City of Sandy

City Council Meeting

Meeting Date: Tuesday, February 22, 2022

Please note: there will be an opportunity to provide testimony for the Deer Meadows Subdivision Appeal later in the agenda.

DEER MEADOWS SUBDIVISION
PRELIMINARY GRADING & EROSION CONTROL PLAN
 40808 & 41010 HWY 26, SANDY, OR 97055

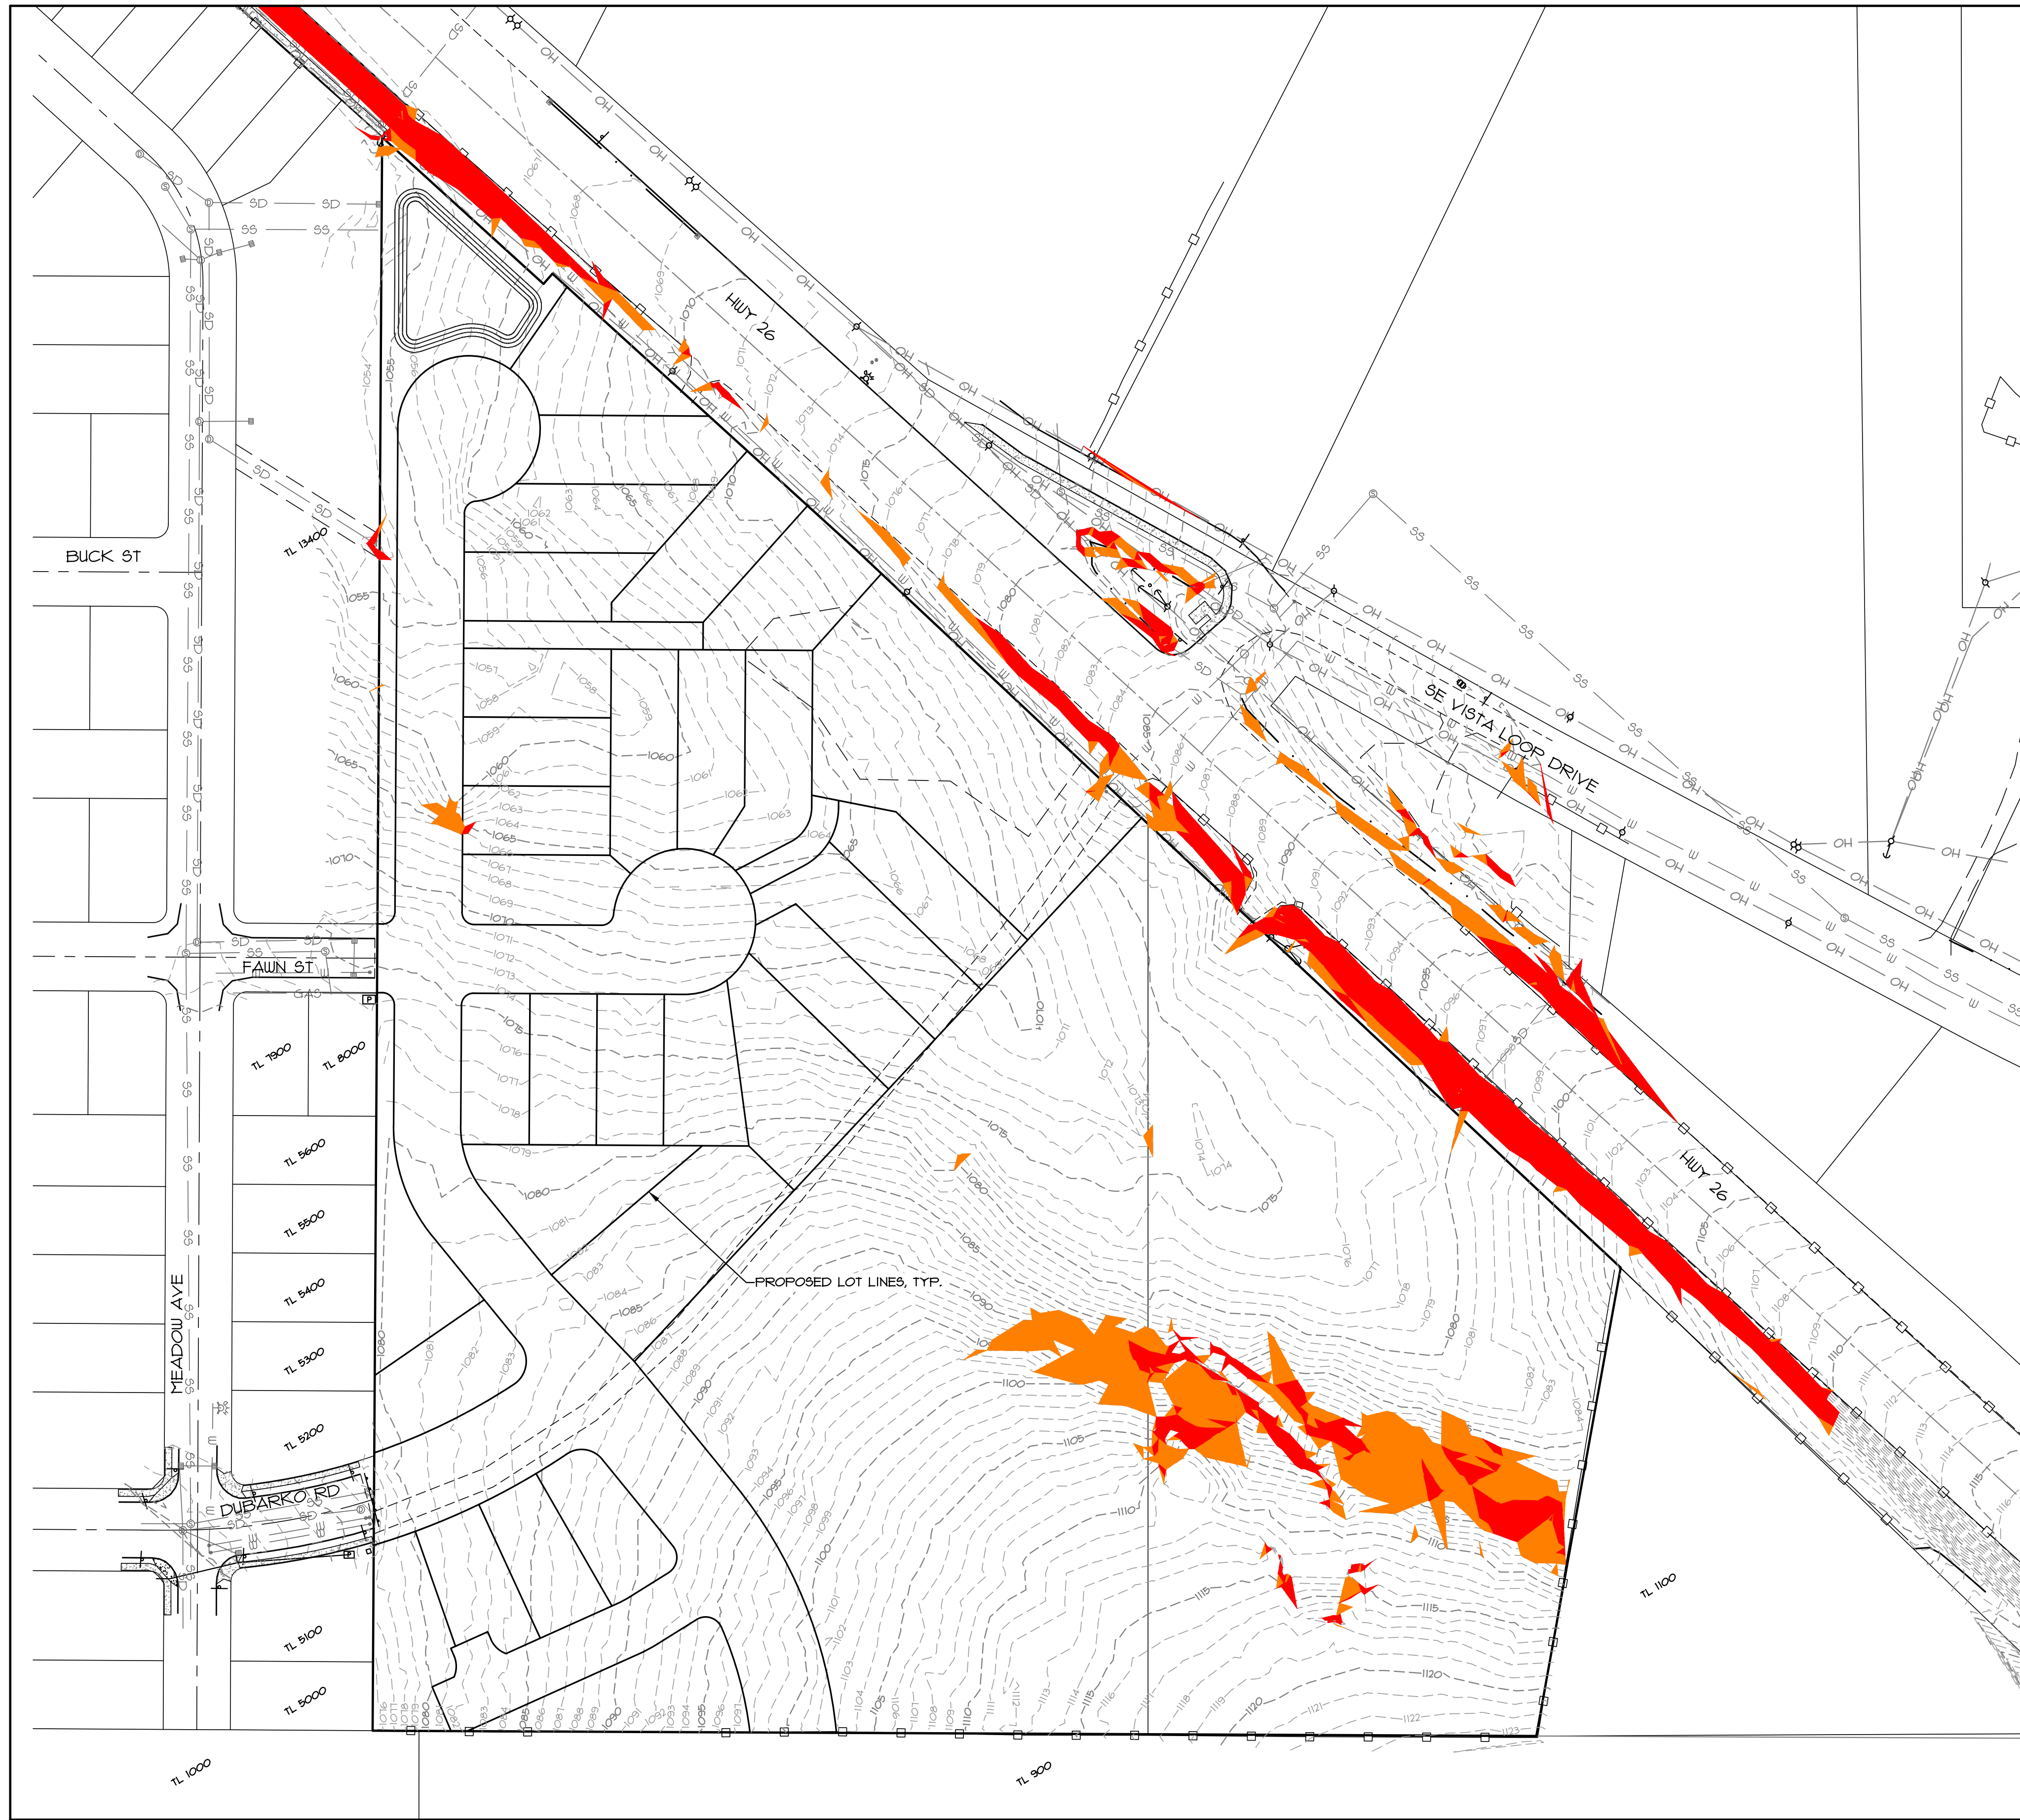
103. Grass seeding shall be completed as required by Section 17.100.300. The submitted preliminary Grading and Erosion Control Plan (Exhibit C, Sheet C7) provides additional details to address erosion control concerns. A separate Grading and Erosion Control Permit will be required prior to any site grading. Erosion control requirements are defined in greater detail in Chapter 15.44 of this document. Section 15.44.50 contains requirements for maintenance of a site including re-vegetation of all graded areas. **The applicant’s Erosion Control Plan shall be designed in accordance with the standards of Section 15.44.50.**
